Private Fuel Storage, L.L.C.

**REQUEST FOR ADDITIONAL INFORMATION
ON AIRCRAFT HAZARDS – PARTIAL RESPONSE
DOCKET NO. 72-22 / TAC NO. L22462
PRIVATE FUEL STORAGE FACILITY
PRIVATE FUEL STORAGE L.L.C.**

**RESPONSE TO MARCH 9, 2001 NRC REQUEST FOR ADDITIONAL INFORMATION
REGARDING AIRCRAFT AND CRUISE MISSILE HAZARDS AT THE
PRIVATE FUEL STORAGE FACILITY**

Skull Valley Weather (Fig. 9-9)

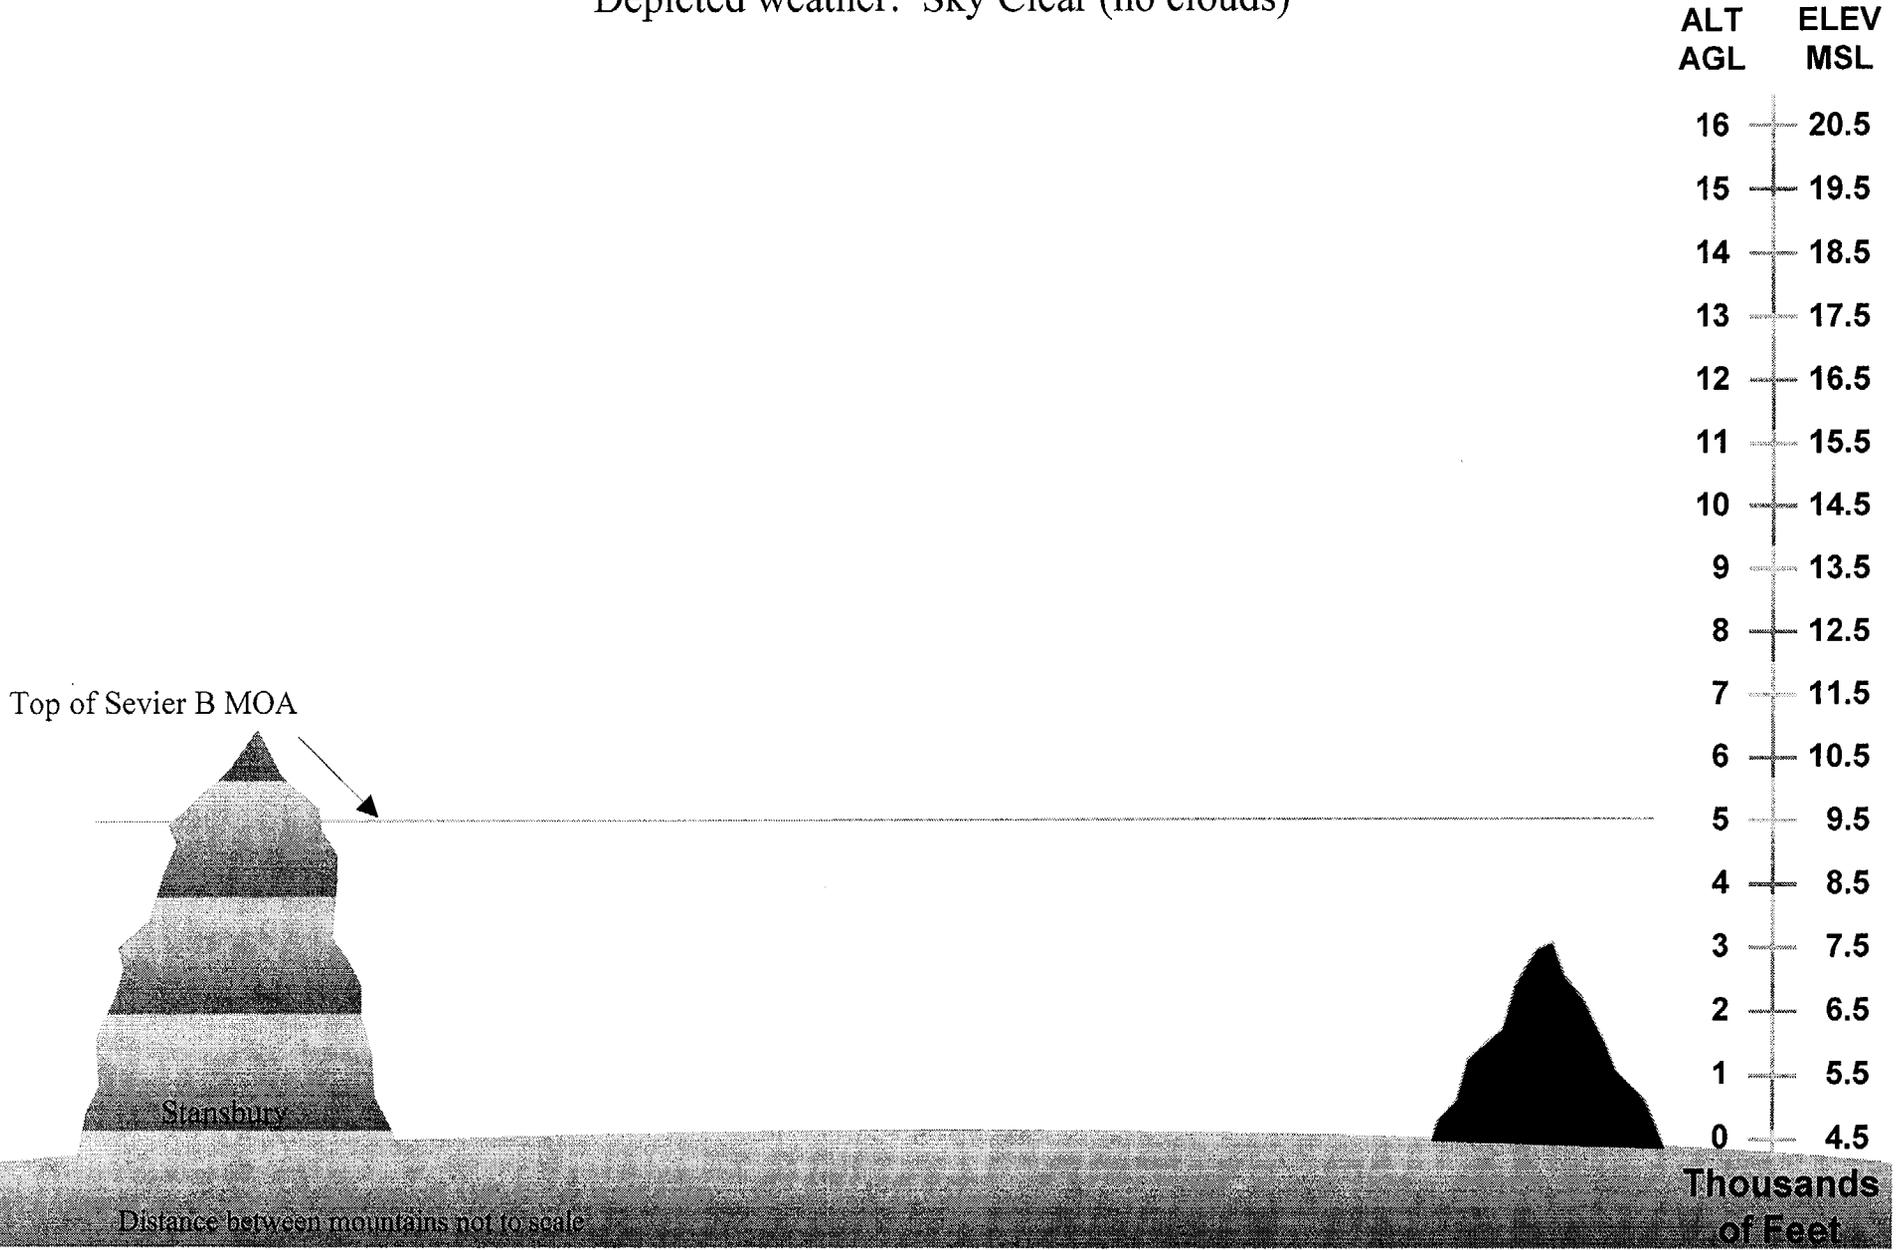
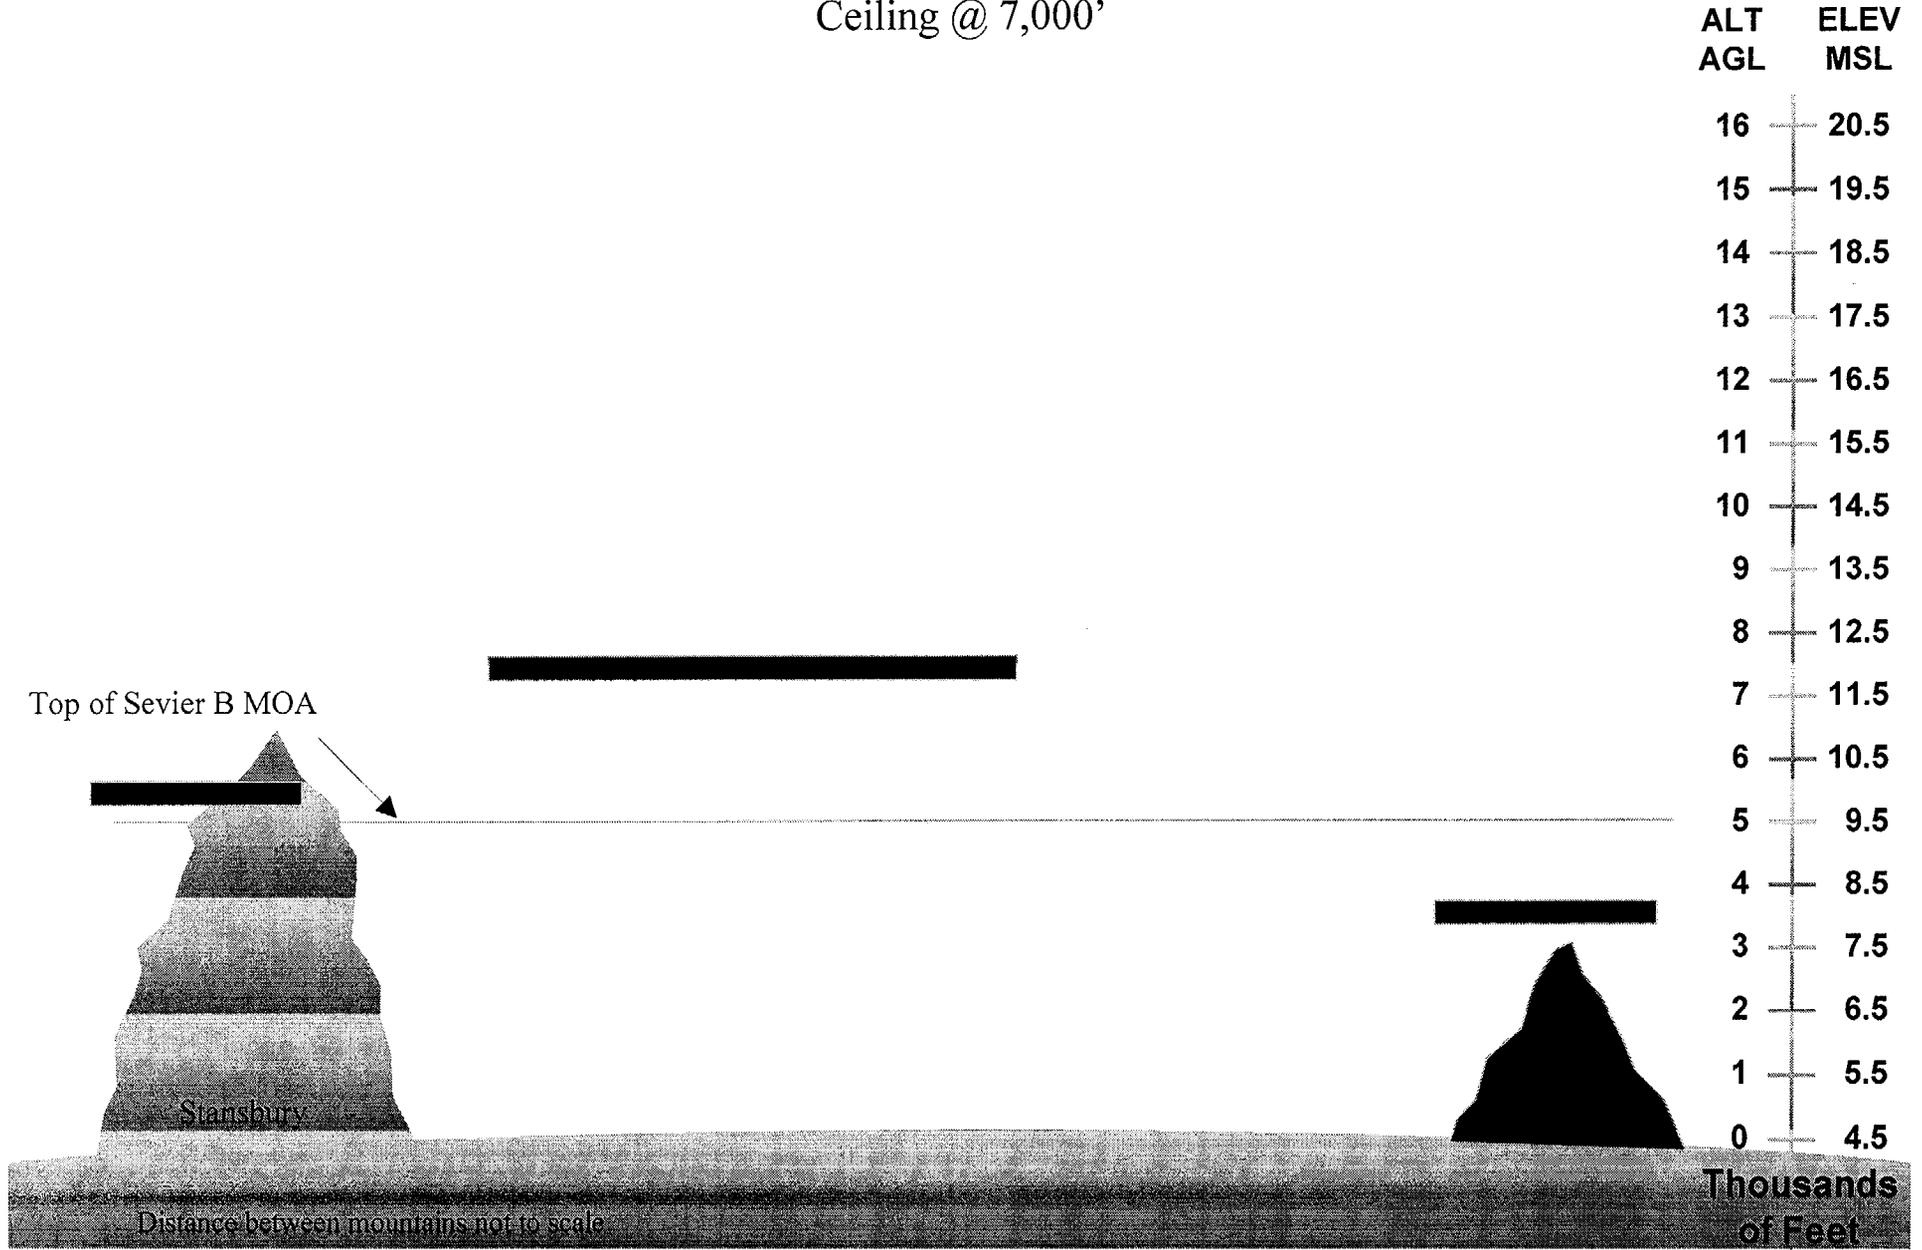
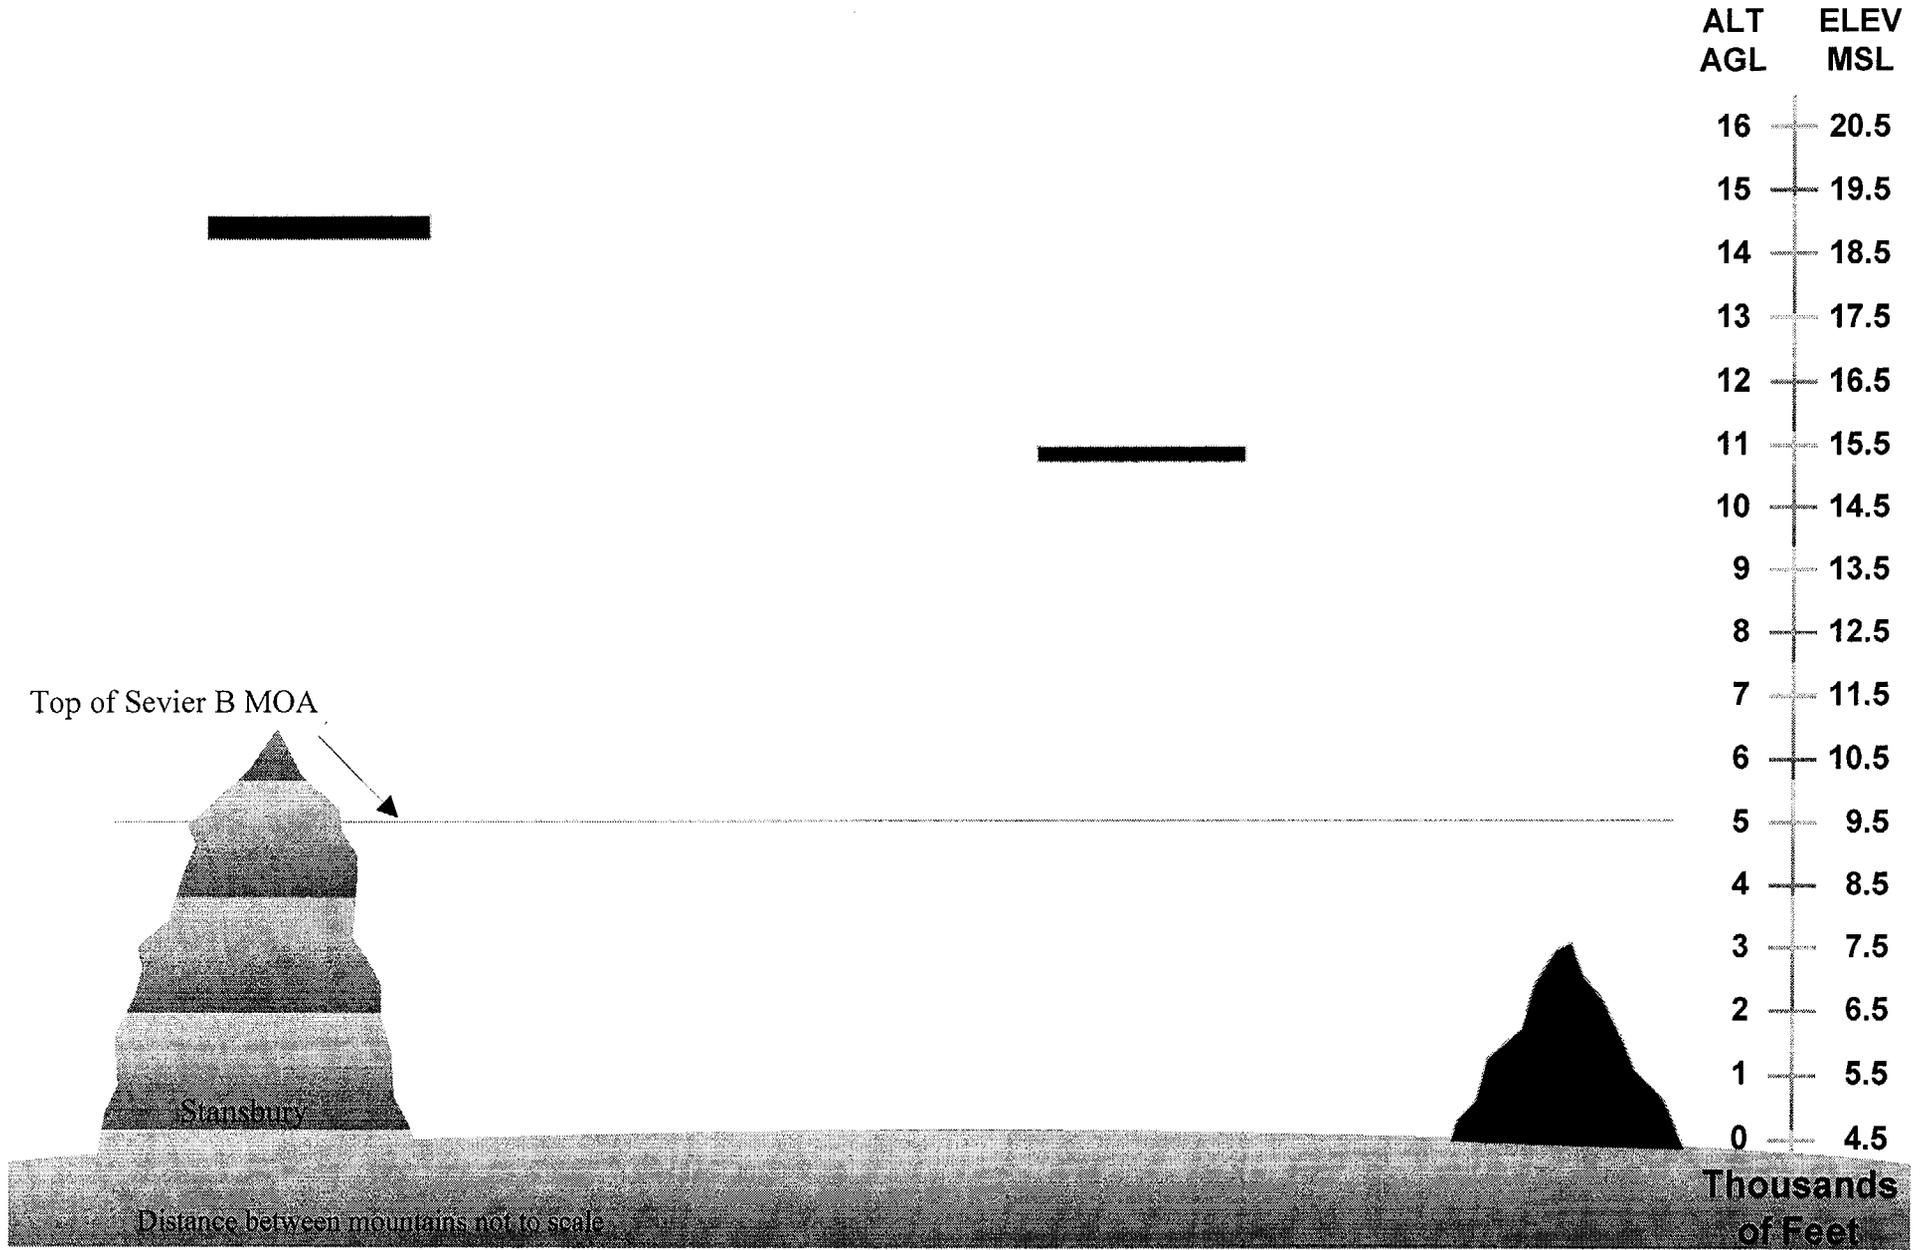
Figures 9-9 through 9-12 show examples of the ceiling and visibility which correspond to the Sevier B MOA. As can be seen from the AWS data, this is the prevailing ceiling and visibility condition 91.5% of the time. In essence, pilots should be able to maintain VFR in the Sevier B MOA the vast majority of the time.
